AGENDA
CITY PLANNING COMMISSION

City Hall - Council Chambers
6131 Taylorsville Road
January 14, 2025
6:00 P.M.

MINOR CHANGE - The applicant, FERGUSON CONSTRUCTION, is requesting approval of a Minor Change for an 11,722 SF building addition for a new gymnasium and additional storage. Property is located at 7251 Shull Road (Case MC 25-01).

DETAILED DEVELOPMENT PLAN - The applicant, TJL-CES, LLC, is requesting approval of a Detailed Development Plan for 0.98 acres to construct a Domino's Pizza (pick-up and delivery only) at 8920 & 8960 Old Troy Pike (Case DDP 25-02).

DOMINO'S
HUBER HEIGHTS
EXTERIOR ELEVATIONS

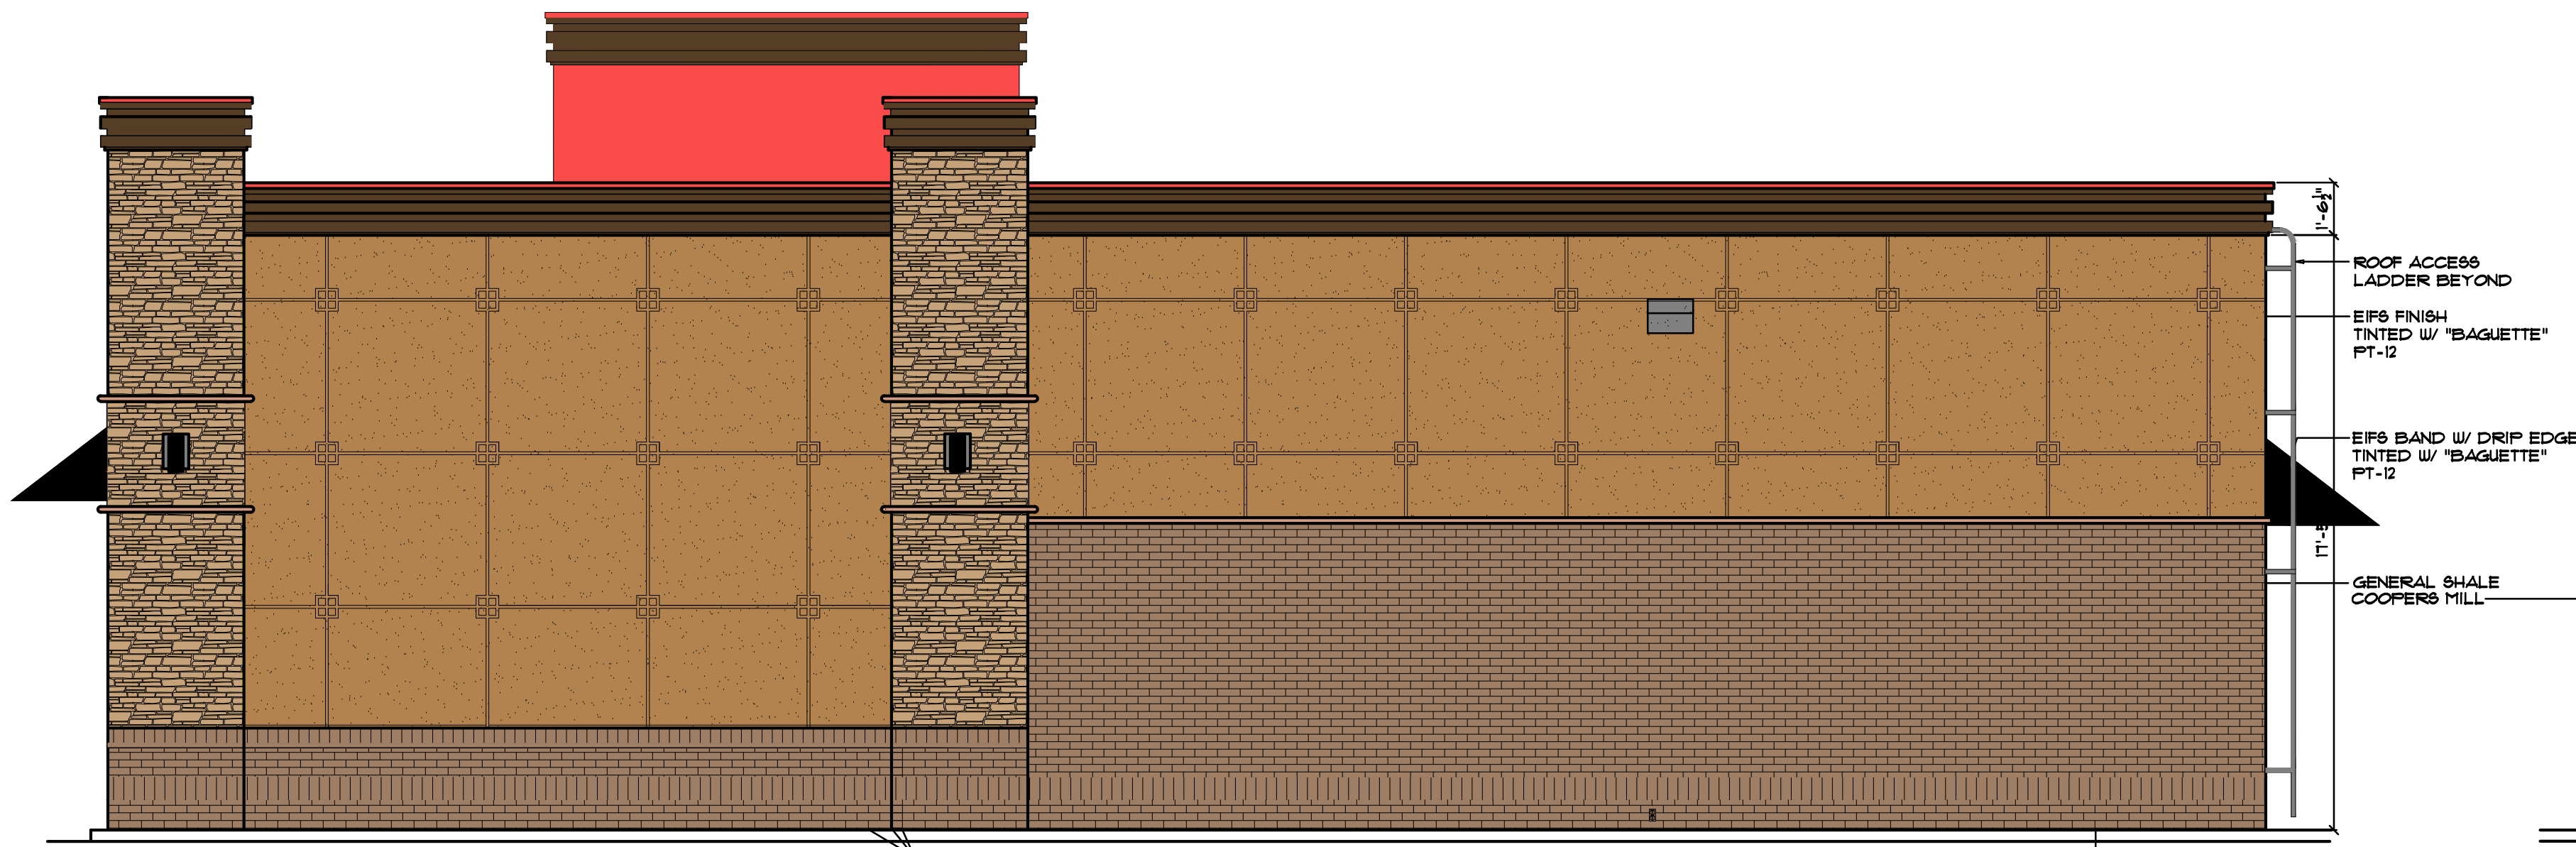
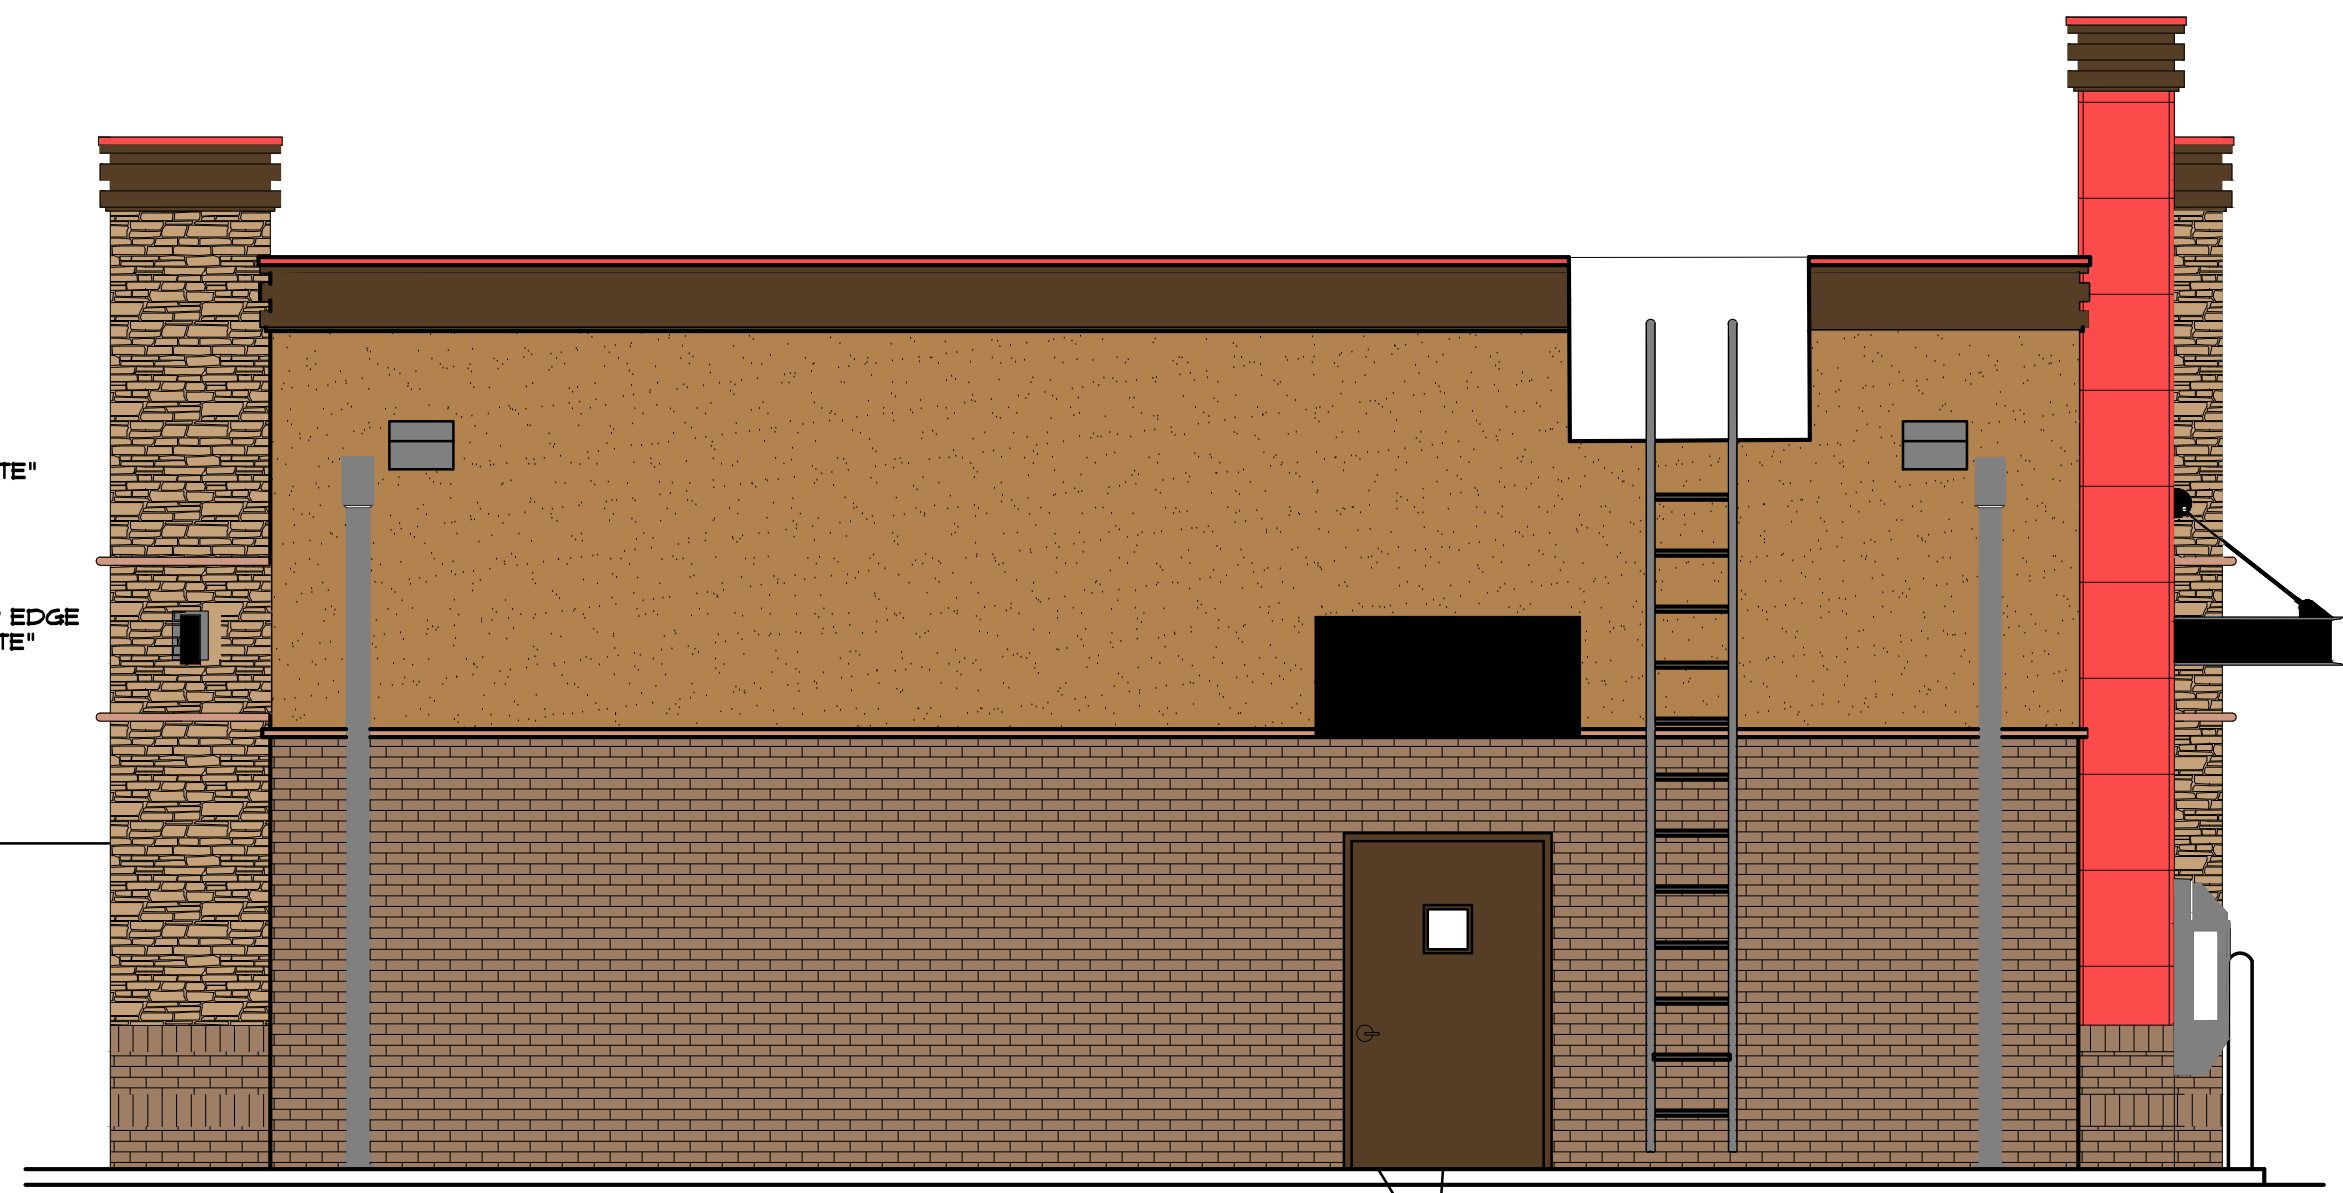
The detailed development plans illustrate one proposed ground sign and a wall sign. The application did not provide sign design details (dimensions, construction type, etc.).

The wall sign illustrated on the plans is approximately 24 square feet. This is well below the 75 square feet permitted under the sign code.
